August 5, 2015

BOARD OF COUNTY COMMISSIONERS
ORANGE COUNTY, FLORIDA
ADDENDUM NO. 1 / IFB Y15-7008-EB

ORANGE COUNTY PUBLIC WORKS COMPLEX PERIMETER FENCE

Chain Link Removal (Indicated in Red) Approx. 3800 lf

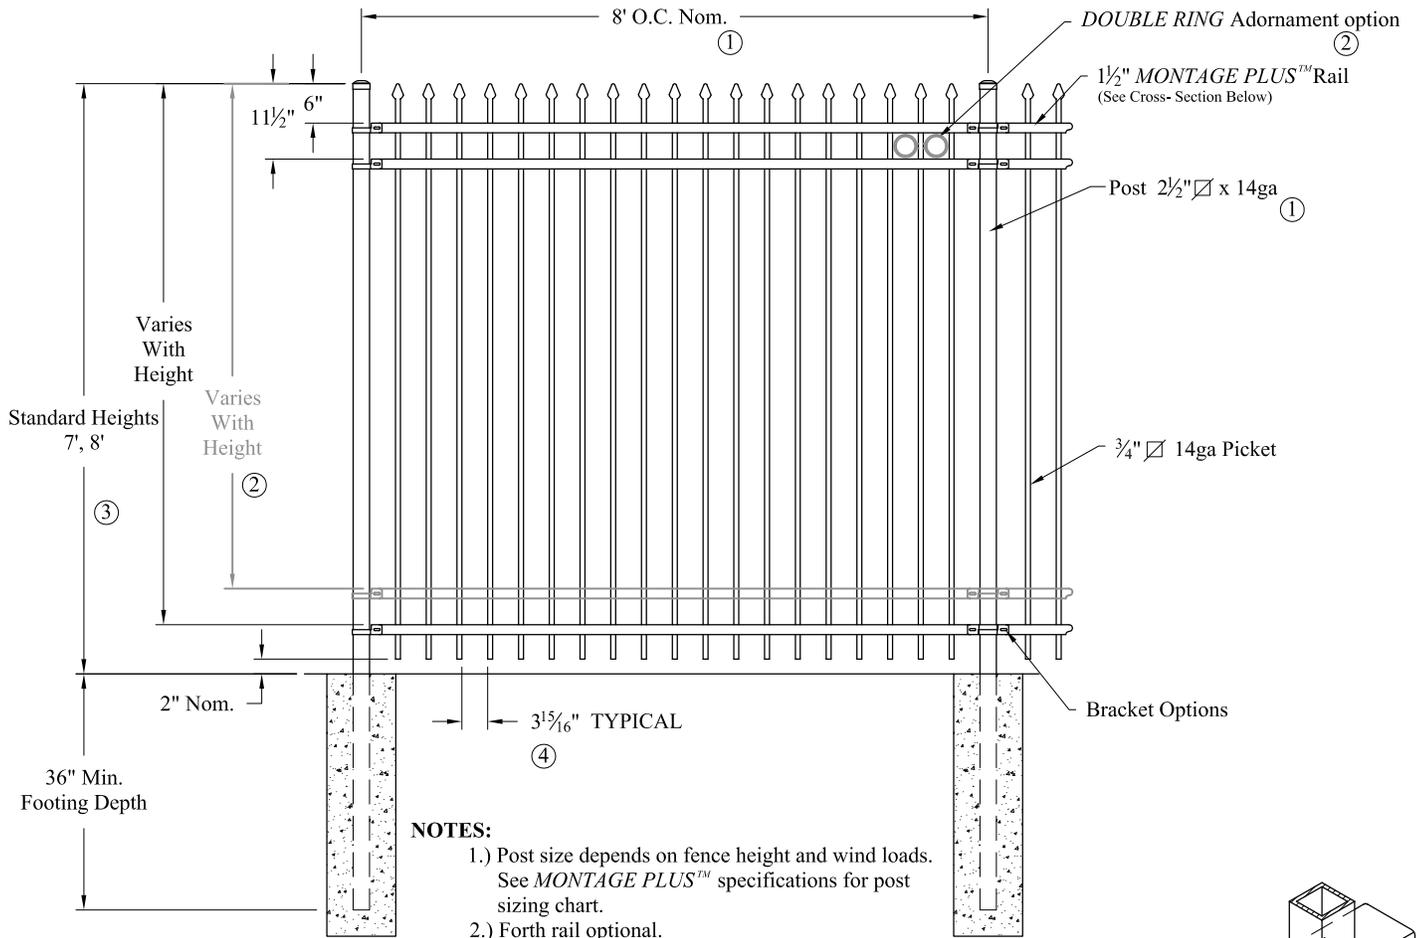
- D. Replace Ameristar Montage Plus Classic drawing with attached Montage Commercial Classic drawing
- E. Insert Chain Link Removal (indicated in Red) photograph to the body of this solicitation.
